Attachment 1 - PLN17/0081- 84 Type Street- Subject Site

Attachment 2 - PLN17/0081- 84 Type Street - Decision plans

I refer to the above Planning Application received on 11 September 2017 in relation to the proposed development at 84 Type Street, Richmond. Council's Engineering Services unit provides the following information:

Attachment 5 - PLN17/0081 - 84 Type Street - Engineering comments

Diagram 1

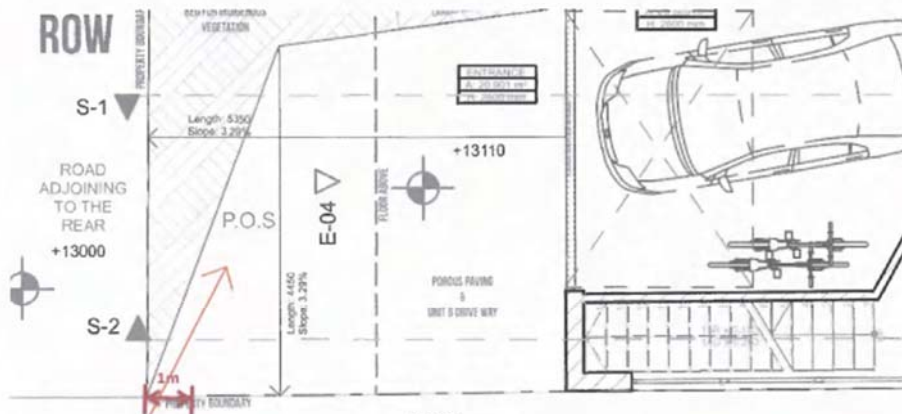
**VEHICLE GATE OPENING**

The vehicle gate opening for Unit B must be a minimum of 4.0 metres in width to provide adequate entry and exit for a B85 design vehicle off Dove Place. The gate opening must commence approximately 1.0 metre from the south-west corner of the site as shown in *Diagram 1* and extend along the southern boundary for a minimum distance of 4m. The vehicle entry into the property may require a correctional movement to access the garage.
